**Governmental Body: Van Meter Planning and Zoning Commission**

**Date of Meeting: Monday June 6, 2022**

**FINAL PLAT  
 TRINDLE RIDGE  
 PLAT 1**

CITY OF VAN METER  
TRINDLE RIDGE PLAT 1  
FINAL PLAT  
REVIEW COMMENTS

FINAL PLAT  
TRINDLE RIDGE PLAT 1  
SHEET 2 OF 3

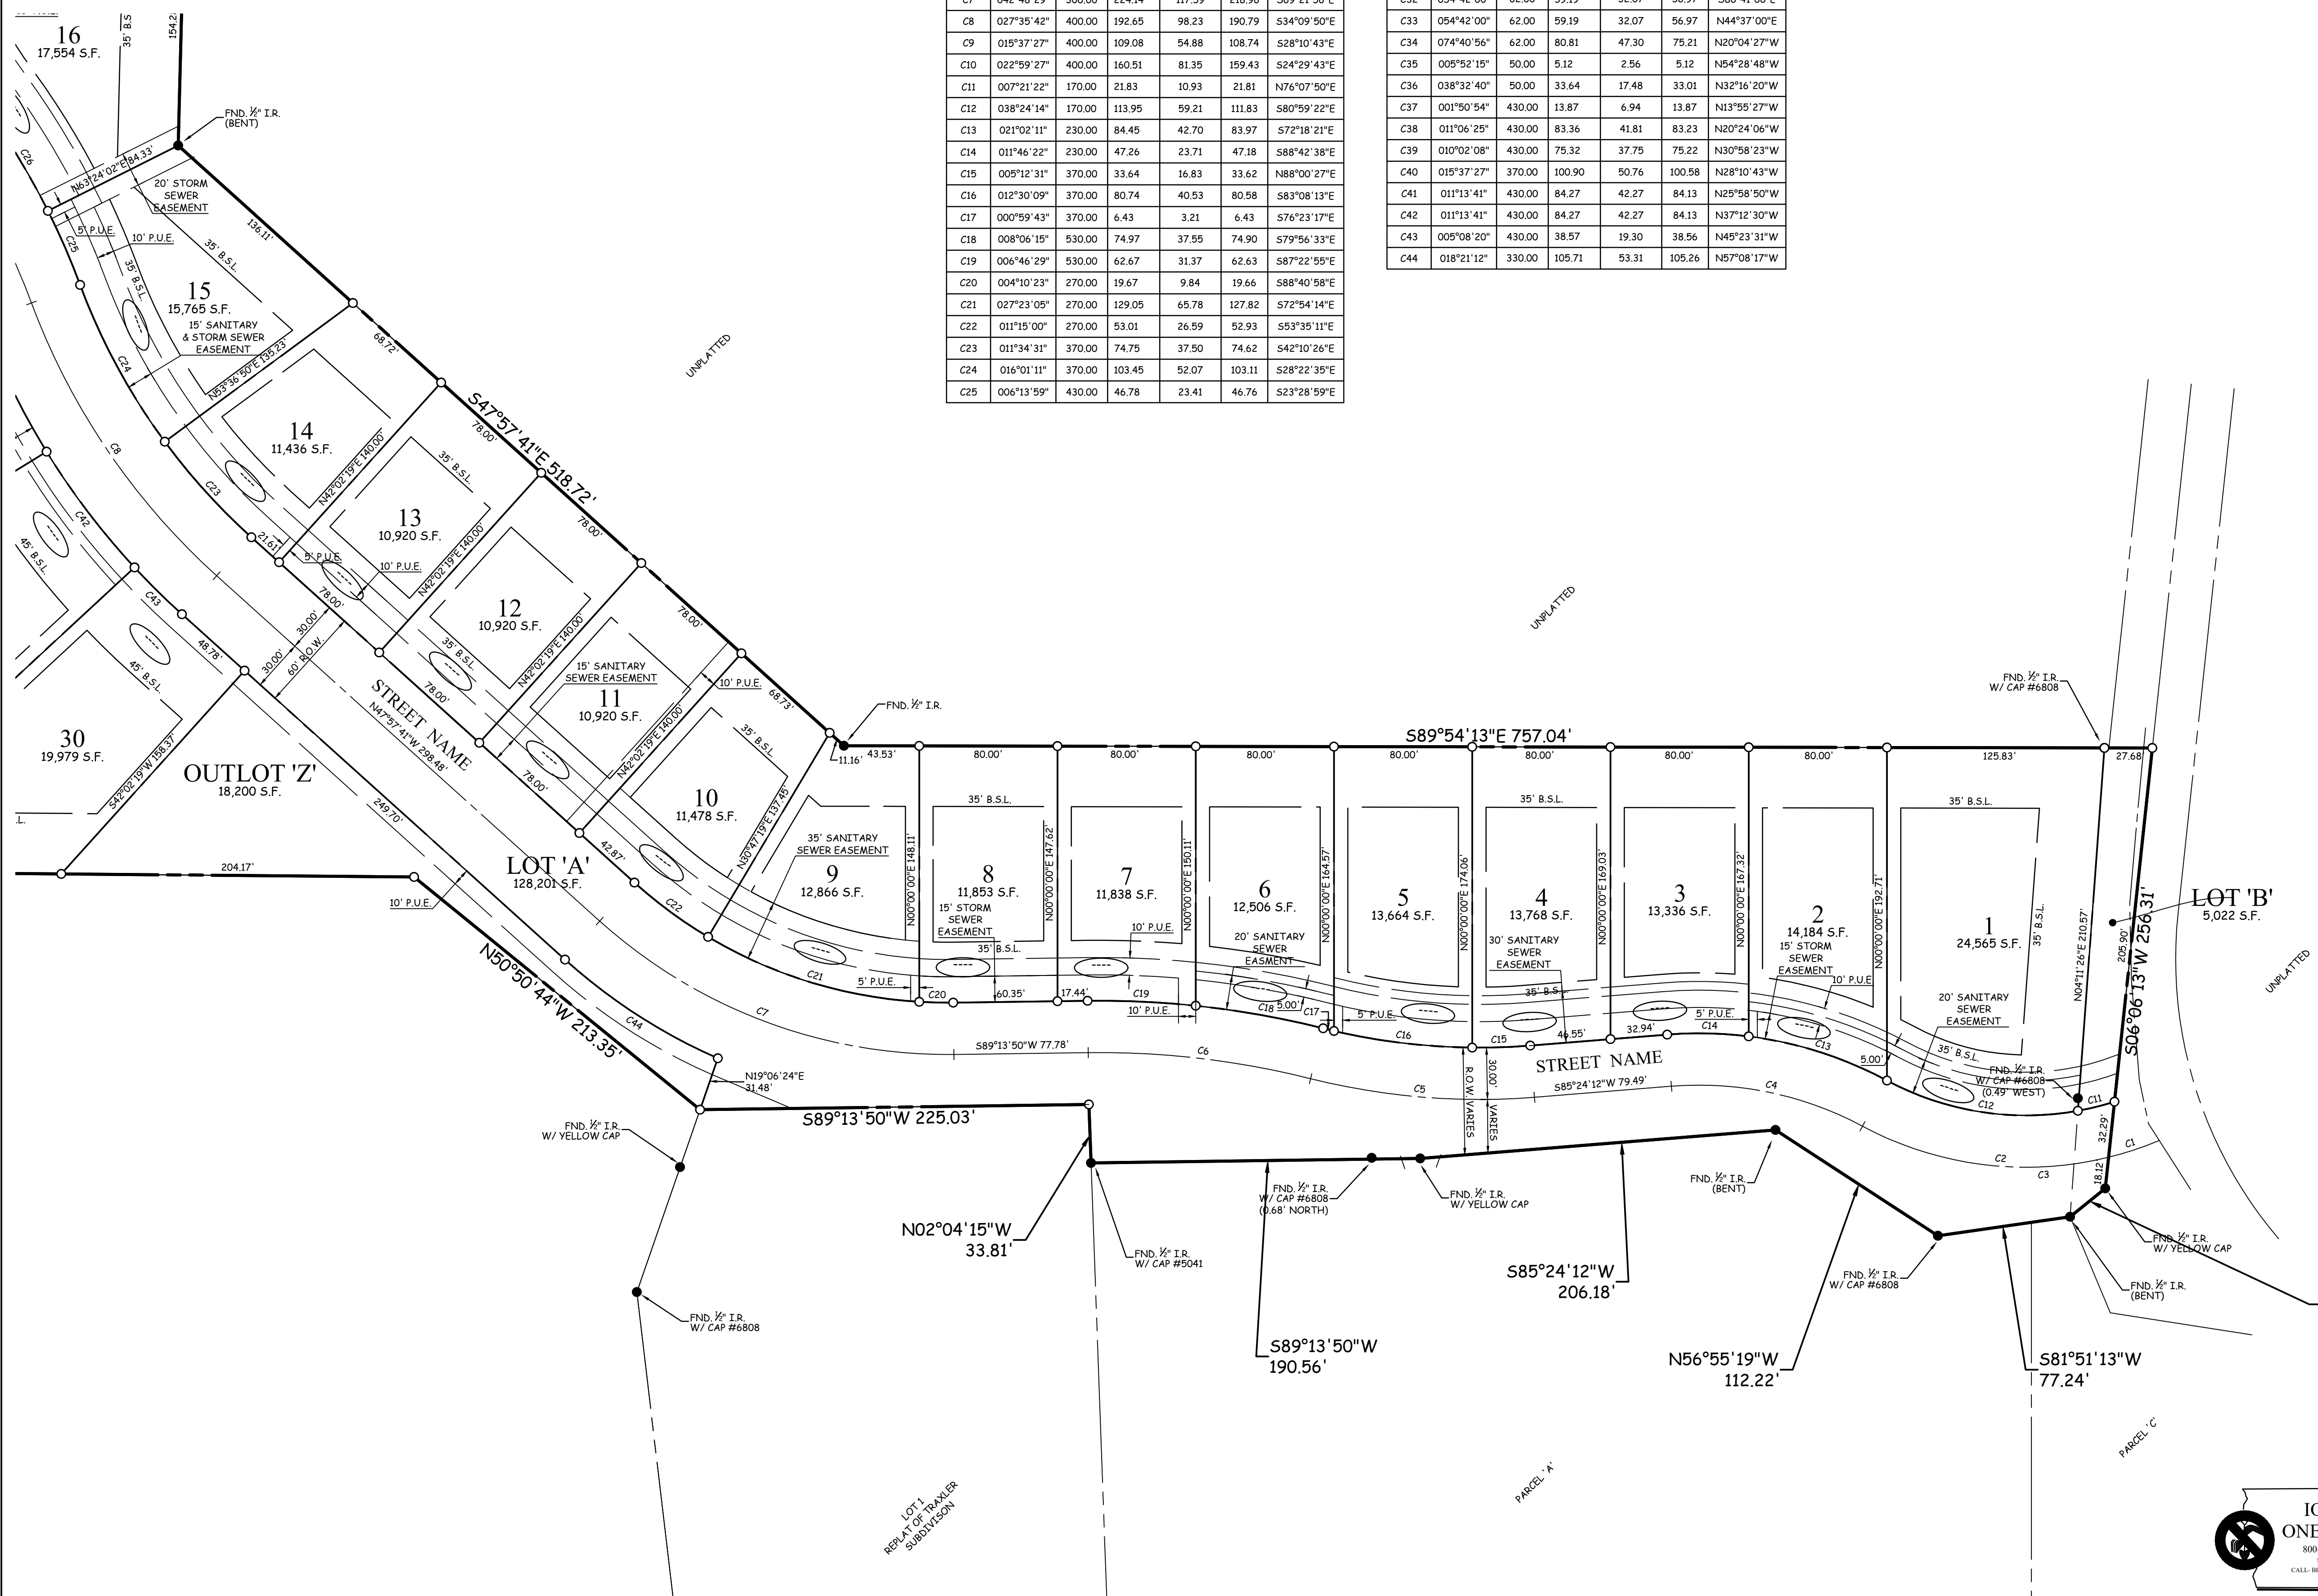
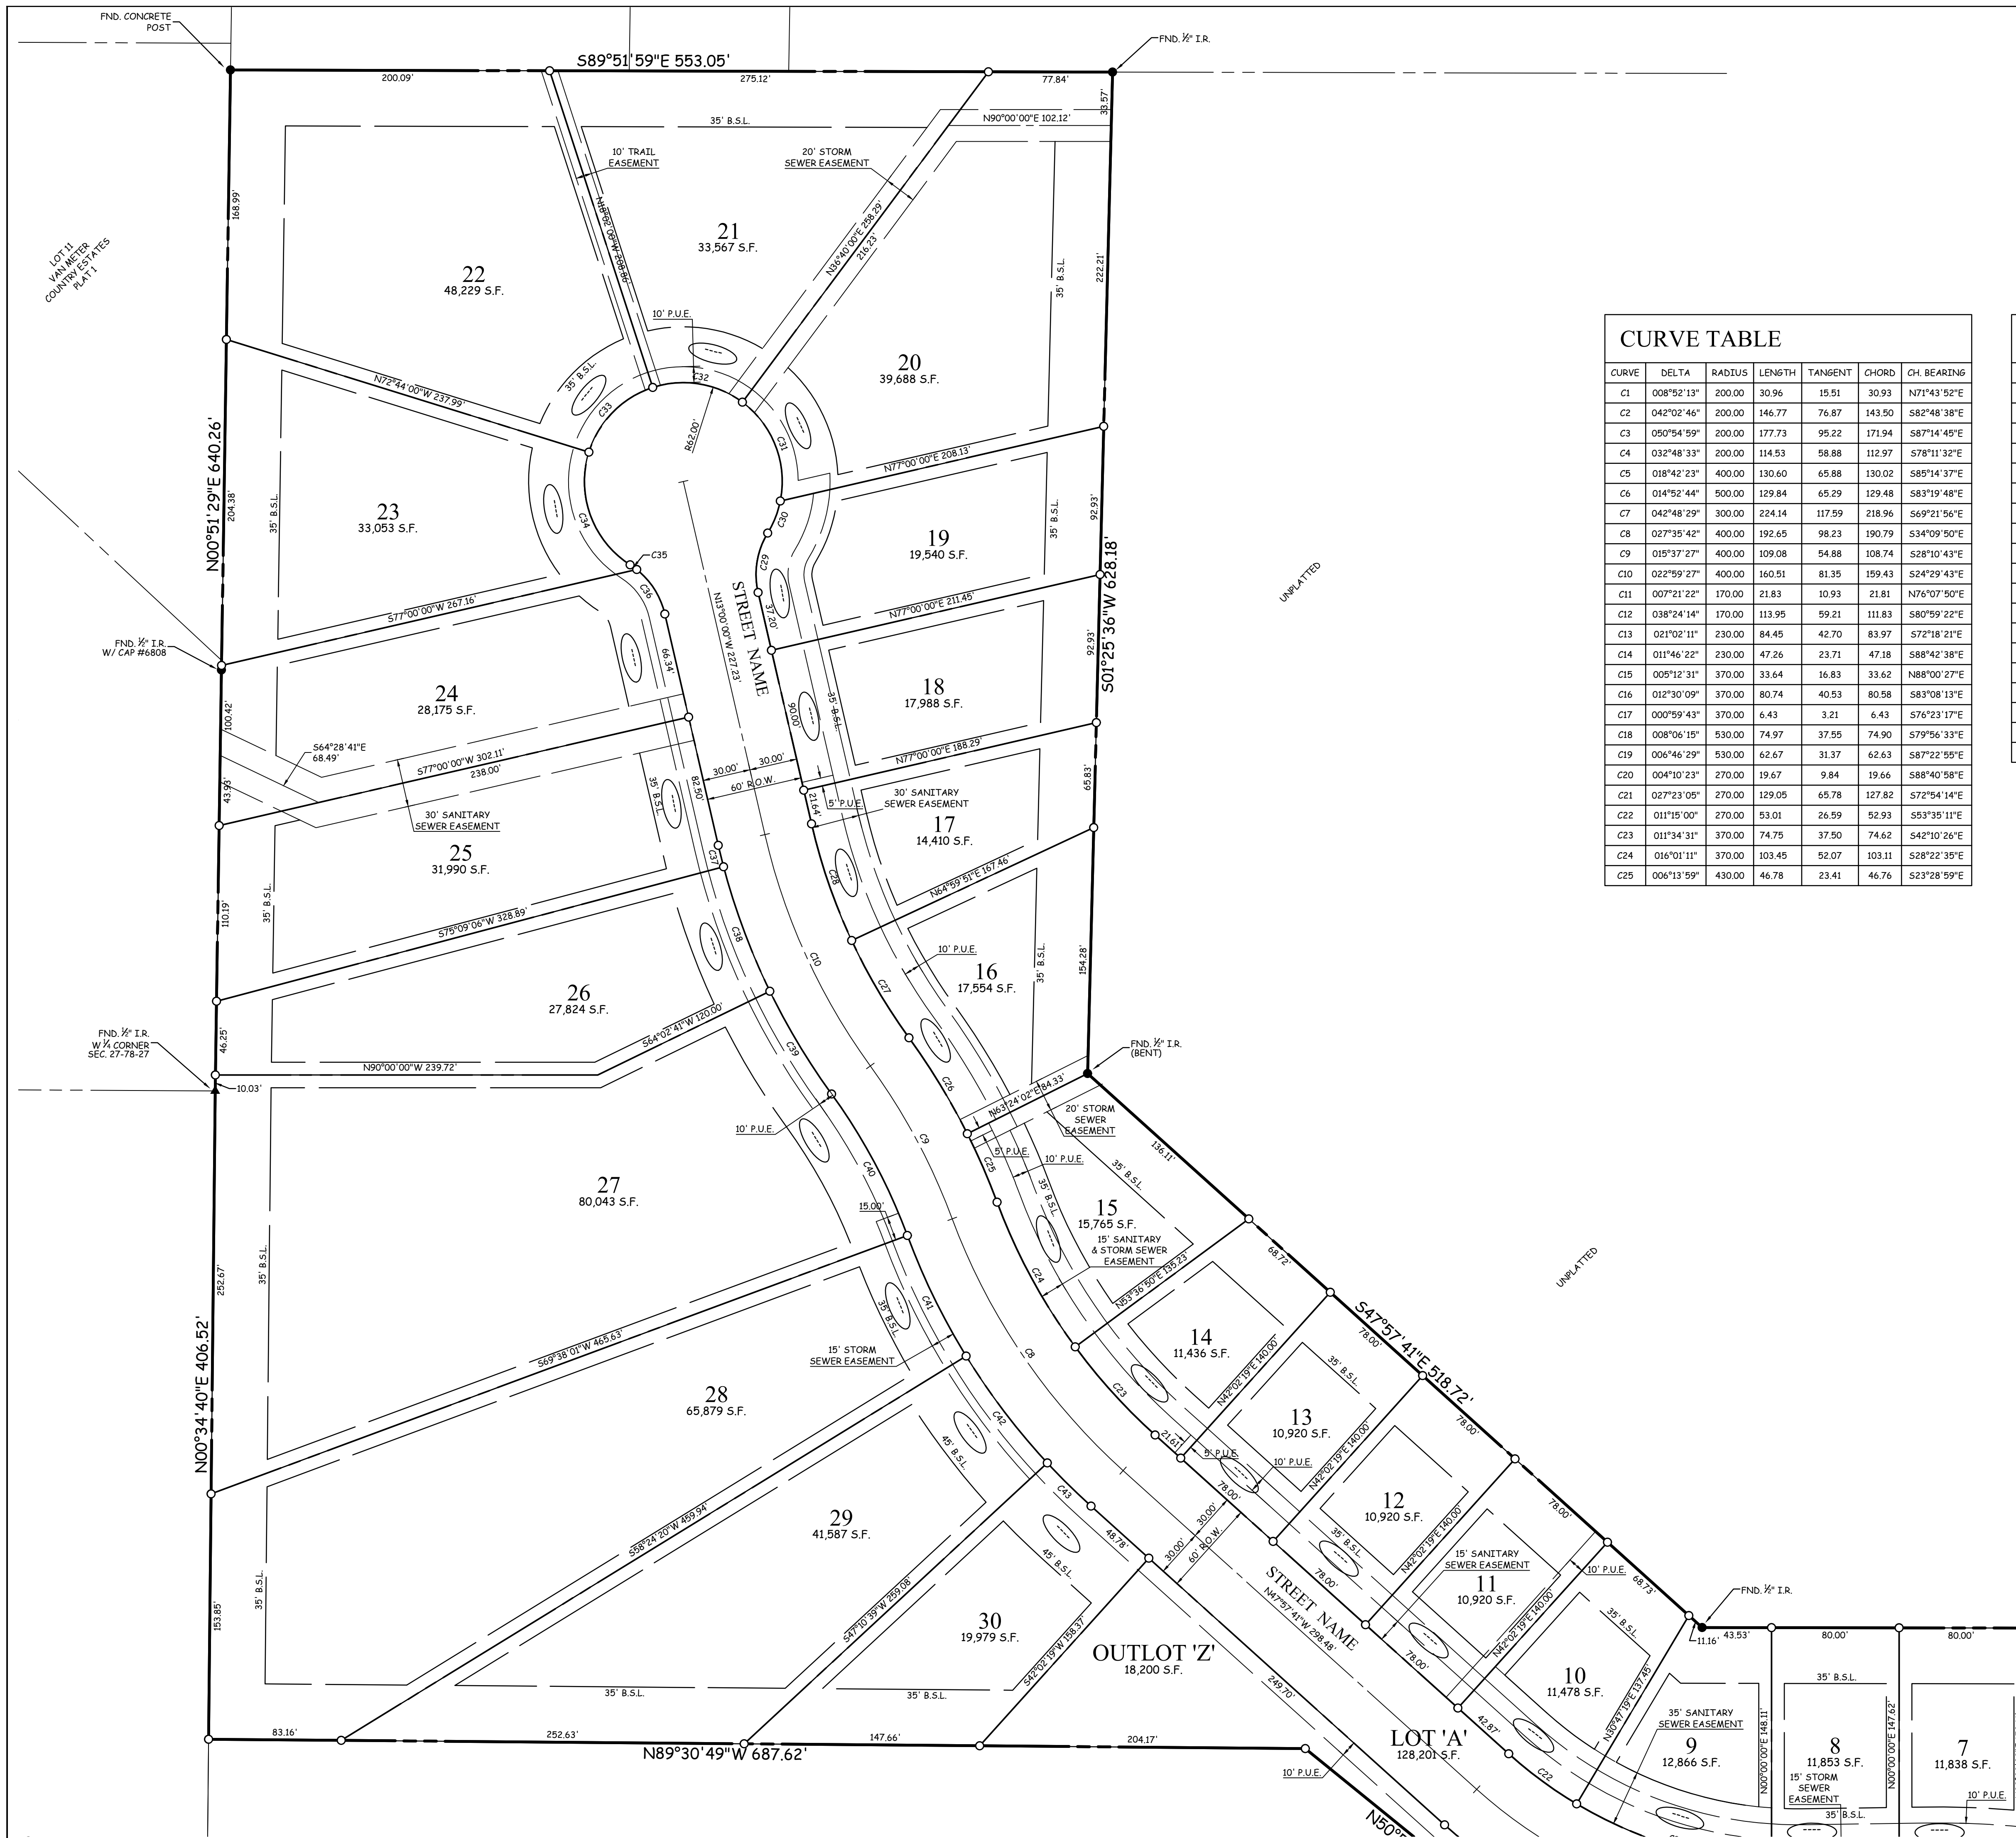
1. The final plat identifies Lot A as the street lot within the plat. The street name should be added to the final plat before its final approval.
2. Lot B includes a portion of the right-of-way of Richland. It is recommended the street name be added.

3. The final plat includes provisions for the lot addresses. Prior to approval of the final plat the City should assign the addresses and the addresses added to the final plat.

4. On Lot 1 there is a dimension of 5.00 feet. It appears this dimension is intended to reference the location of the northerly boundary of the 20 foot sanitary sewer easement with the southerly boundary of the 10 foot PUE that overlaps the sanitary sewer easement. This understanding of the dimension 5.00 feet should be confirmed.

5. In the street right-of-way southerly of Lot 9 there is an unlabeled diagonal line crossing the corner of the street right-of-way. This line should be clarified.

6. The final plat includes a 15 foot wide storm sewer easement on Lot 29, Lot 28 and a small portion of Lot 27. It is understood the storm sewer easement is for the storm service lines for Lot 28 and Lot 29.

11. On a portion of Lot 27, on all of Lot 26, and Lot 25 and a portion of Lot 24 there is a line shown several feet westerly of the 10 foot PUD. This line is unlabeled. The line needs to be labeled or removed.

12. The final plat includes the building setback locations for the front, rear and side yards of all lots.
13. The final plat includes areas where a Public Utility Easement overlaps a City of Van Meter designated easement for storm sewer or sanitary sewer. The final plat will need to include a note indicating that any utility occupying the public utility easement is subordinate to the City's rights in the designated utility easement and any utility in the PUE must relocate at no cost to the City if the occupancy in the PUE is in conflict with the City's use of its designated easement whether initially or at a future date.

14. The final plat does not show any new water main easements. If the existing water main is located entirely within existing easements these easements should be shown on the final plat with the book and page referral. If there is no recorded easement or some part of the water main is located outside of an existing easement a new easement for the water main must be shown in the final plat.

1. Street name added
2. Name added
3. Still need street addresses from the City to add to the final plat
4. Dimension has been confirmed and revised
5. Line has been revised
6. Easement is for services
7. So noted
8. So noted
9. So noted
10. So noted
11. Line was removed
12. So noted
13. So noted
14. The water main easements have been added, but we still need to research the existing watermain easement per the title opinion. This will happen prior to City Council approval.
